# UNITED STATES PATENT AND TRADEMARK OFFICE

APPLICATION NO.	FILING DATE	FIRST NAMED INVENTOR	ATTORNEY DOCKET NO.	CONFIRMATION NO.
10/672,022	09/26/2003	Neal E. Ulen	P16919	7687
28062	7590	10/25/2005	EXAMINER	
BUCKLEY, MASCHOFF, TALWALKAR LLC			PAPE, ZACHARY	
5 ELM STREET			ART UNIT	
NEW CANAAN, CT 06840			PAPER NUMBER	
			2835

<b>Office Action Summary</b>	<b>Application No.</b> 10/672,022	<b>Applicant(s)</b> ULEN ET AL.	
	<b>Examiner</b> Zachary M. Pape	<b>Art Unit</b> 2835

## **DETAILED ACTION**

Fig 1

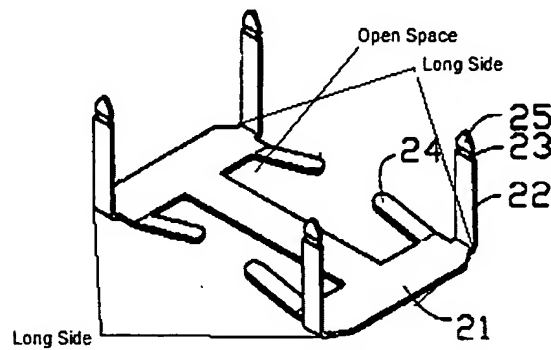
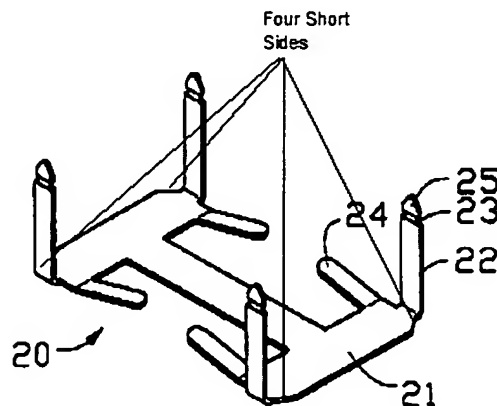
With respect to claim 11, Lee teaches a spring (Fig 3, 20) comprising: a perimeter section including a plurality of sides around an open space a first spring finger (24) extending inwardly and upwardly in an inclined fashion from a first one of the sides; a second spring finger (Also 24) extending inwardly and upwardly in an inclined fashion from a second one of the sides that is opposite to the first one of the sides; four board attach fingers (25) each extending substantially vertically upwardly from the perimeter section, a first one of the board attach fingers located at a first end of the first one of the sides a second one of the board attach fingers located at a second end of the first one of the sides, a third one of the board attach fingers located at a first end of the second one of the sides, and a fourth one of the board attach fingers located at a second end of the second one of the sides, and four bosses (22) formed in the perimeter section each of the bosses located so as to have a respective one of the board attach fingers (25) extending upwardly therefrom: wherein the perimeter section is substantially octagonal and includes a pair of long sides that are positioned opposite to each other and that are longer than the sides from which the first and second spring fingers extend, the perimeter section further including four short sides that are shorter than the sides from which the first and second spring fingers extend, each of the short sides joining an end of one of the long sides to an end of one of the sides from which the first and second spring fingers extend; said long sides (See present office action Figs 1 and 2 below).

Lee fails to teach that the short sides and said sides from which the first and second spring fingers extend together forming a closed octagonal loop, however it would have been obvious to one of ordinary skill in the art at the time the invention was made to connect the two spring fingers (24) on each side respectively to close the gap between the two springs forming a closed loop and thus increasing the rigidity of the spring fingers.
